NL-17-035

SUBJECT: Proposed License Amendment Regarding Connection of Non-Seismic Boric Acid Recovery System to the Refueling Water Storage Tank
Indian Point Unit No. 2
Docket No. 50-247
License No. DPR-26

ANALYSIS OF PROPOSED TECHNICAL SPECIFICATIONS CHANGE
REGARDING CONNECTION OF NON SEISMIC BARS
TO REFUELING WATER STORAGE TANK

INDIAN POINT 2 DRAWINGS AND CALCULATION

TITLE: FLOW DIAGRAM
CHEMICAL & VOLUME CONTROL SYSTEM -
UFSAR FIGURE No. 9.2-1 (SHT. 1)

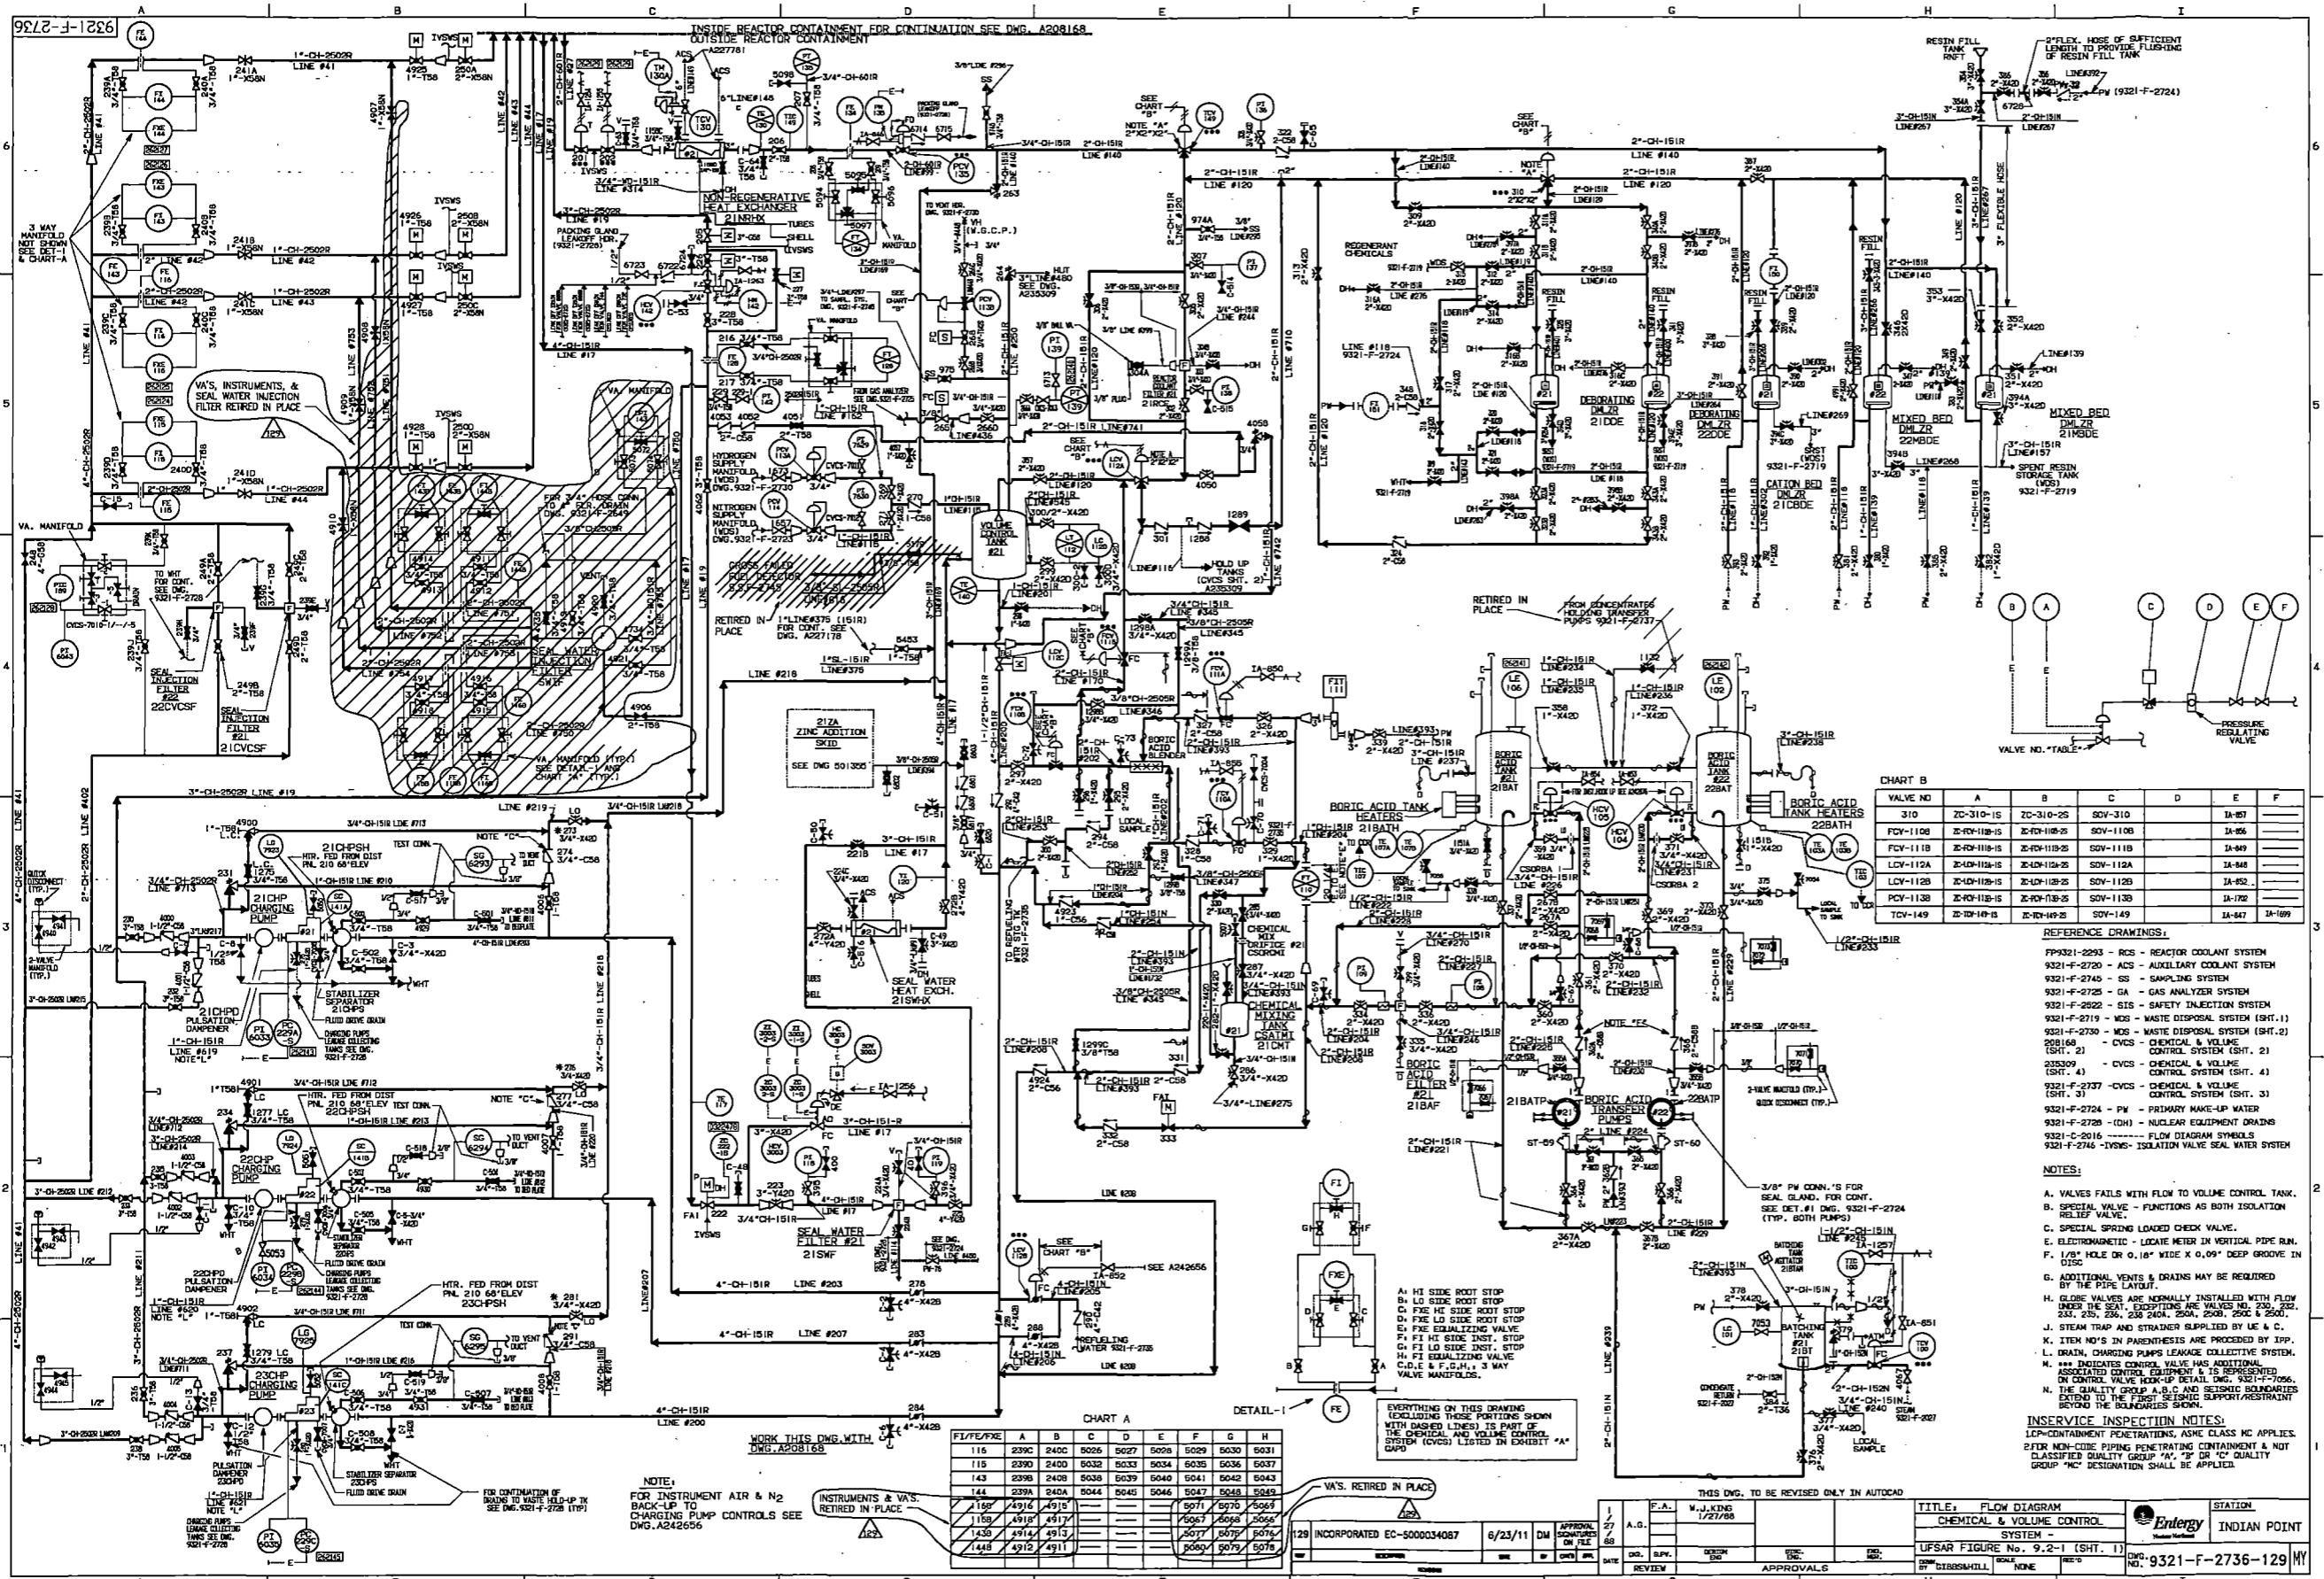
- The BARS discharge line is connected to 2 inch line #252 upstream of 2 inch valve 350 (see Drawing 9321-F-2736, quadrant E-3 and Drawing 9321-F-2735 (valve 350 only), quadrant I-4 in the Enclosure) by removing the 2"-150 psig flange and installing a hose adapter plate.
